V2500-A1/A5/D5 SERIES PROPULSION SYSTEMS SERVICE BULLETIN

V2500-ENG-75-0090

AIR – ACTIVE CLEARANCE CONTROL VALVE – INTRODUCTION OF AN ACC VALVE WITH REVISED
ACTUATING ROD SLEEVE BEARINGS

V2500-A1 ACC Valve Family Tree
Figure 1 (sheet 1 of 2)

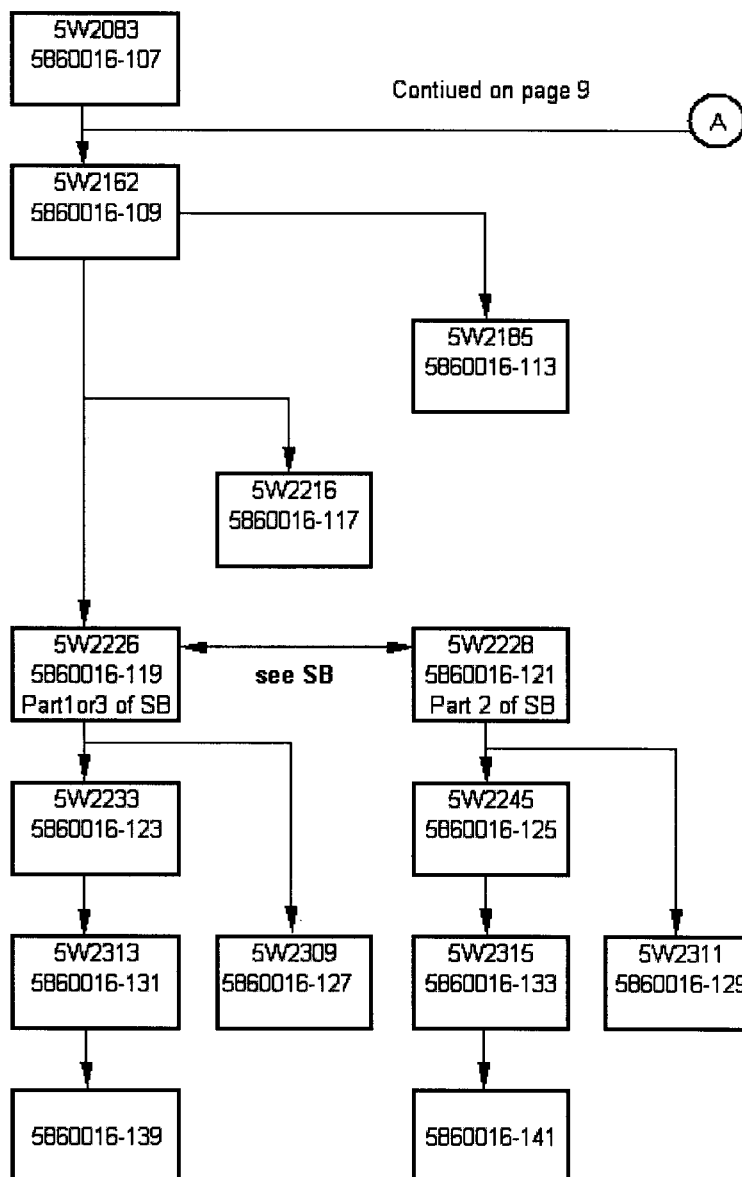
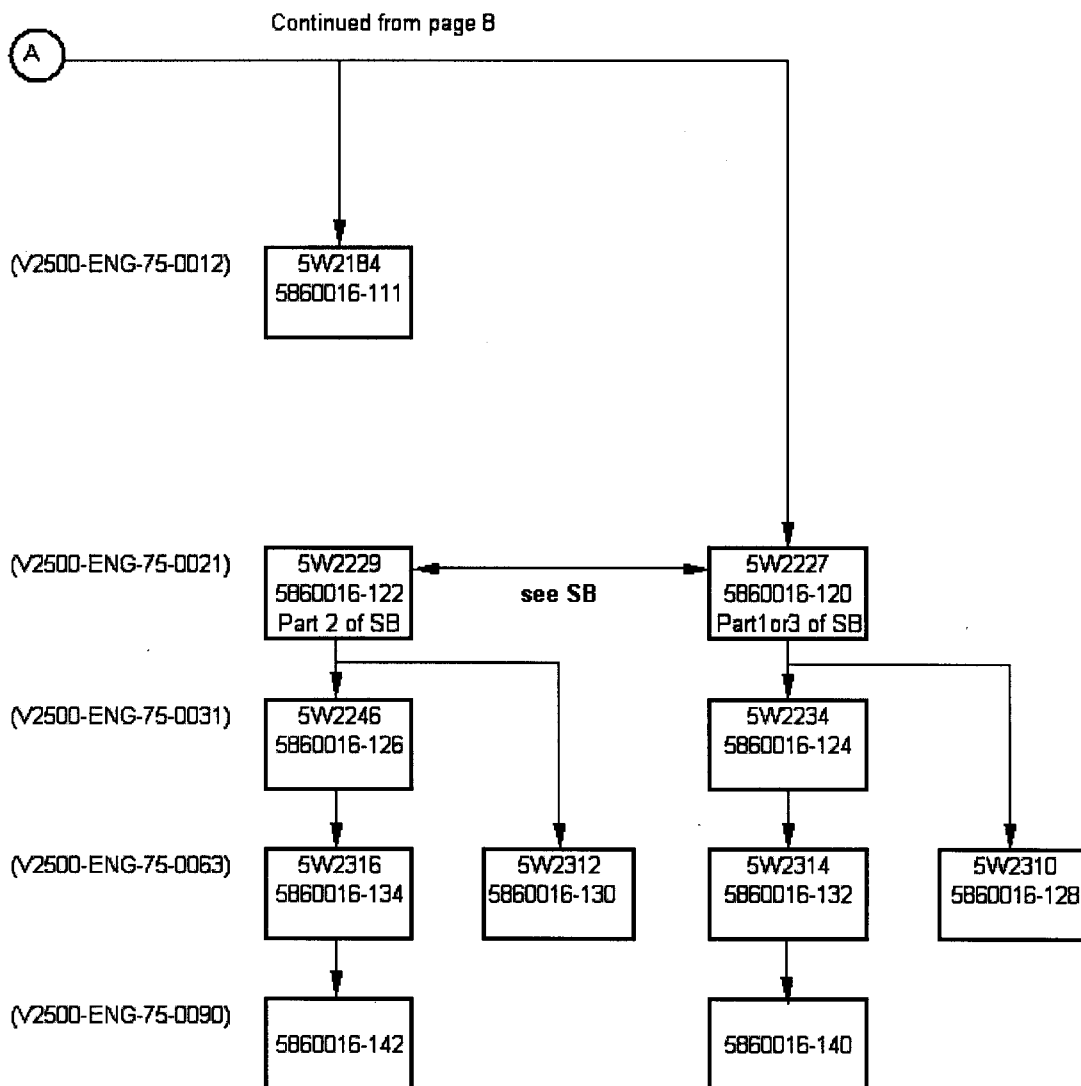
V2500-ENG-75-0090

Introduction of an ACC Valve with revised actuating rod sleeve bearings

Family Tree
Figure 1

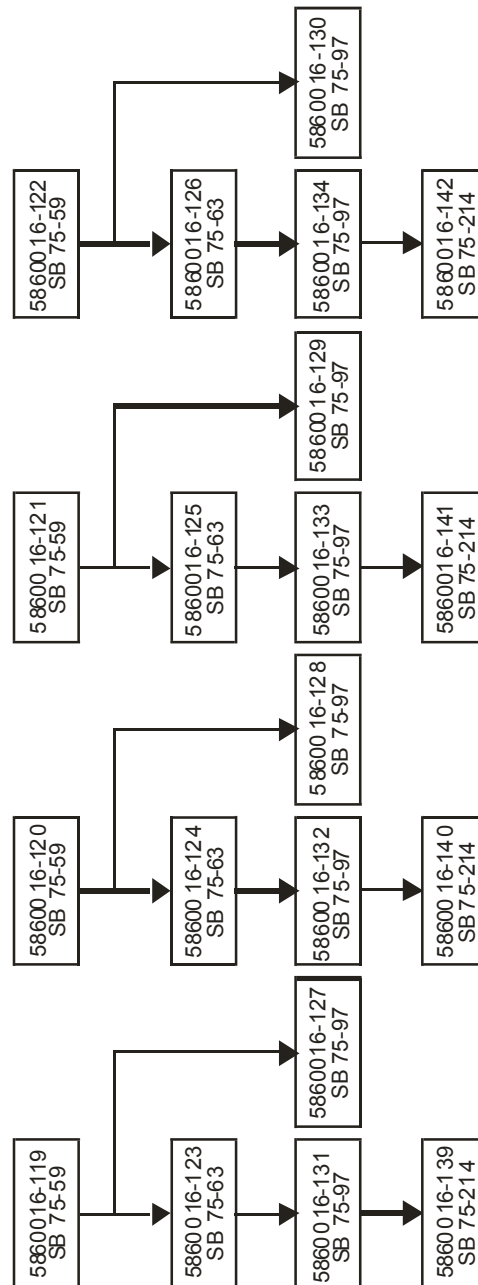
- (1) This service bulletin provides instructions to return ACC Valves, 5860016-131 through -134, to Parker for modification, testing, and re-identification.
 - (a) Modified ACC Valves, 5860016-131 or -133, will be upgraded to a 5860016-139 or -141 configuration respectively.
 - (b) Modified ACC Valves, 5860016-132 or -134, will be upgraded to a 5860016-140 or -142 configuration respectively.

OLD CONFIGURATION NUMBER	NEW CONFIGURATION NUMBER
5860016-131	5860016-139
5860016-132	5860016-140
5860016-133	5860016-141
5860016-134	5860016-142

Family Tree
Figure 1

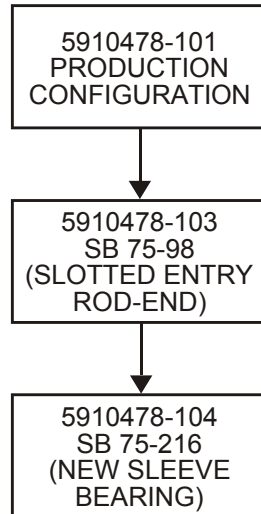
(a) Modified ACC Valves, 5910478-101, will be upgraded to a 5910478-104 configuration incorporating service bulletin 5910478-75-98.

(b) Modified ACC Valves, 5910478-103, will be upgraded to a 5910478-104 configuration.

OLD CONFIGURATION NUMBER	NEW CONFIGURATION NUMBER
5910478-101	5910478-104
5910478-103	5910478-104
